**E4419B-16**

# S E R V I C E N O T E

## Agilent E4419B EPM Average Power Meter

### Front Panel Dimension Might Not Be Suitable For Rack Mounting Solutions

Figure 1

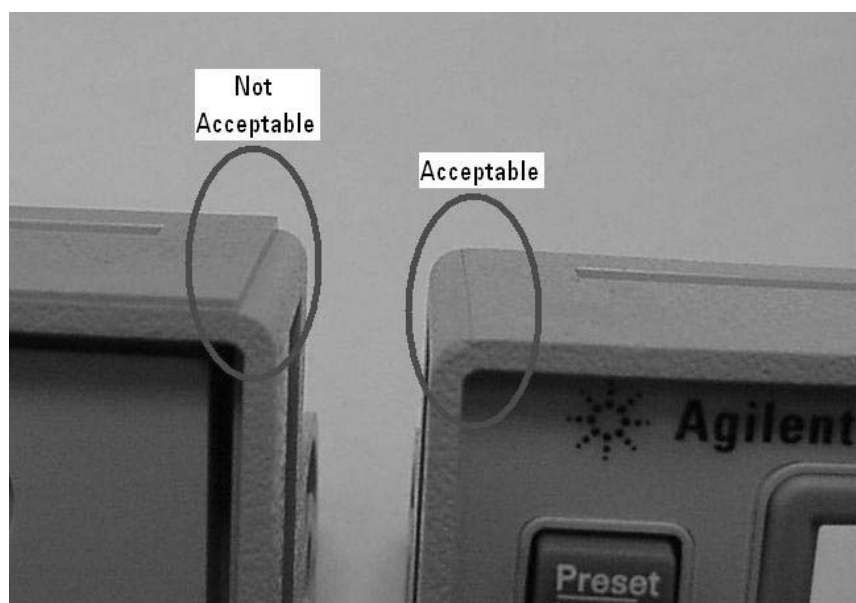
A tooling issue has resulted in some E4419B power meters being shipped with excess material on the top edge of the Front Panel Assembly. The height of this excess material varies, but it has been noted that when it exceeds 0.5mm the meter may no longer be suitable for rack mounting solutions.

Figure 1 shows the physical difference between an acceptable and an unacceptable Front Panel Assembly.

If the height of the excess material is 0.5mm (or less), then no further action is necessary.

If the height of the material exceeds 0.5mm, then the Front Panel Sub-assembly must be replaced (refer to Service Note E4419B-14 for instructions on how to remove & replace the Front Panel Sub-Assembly).
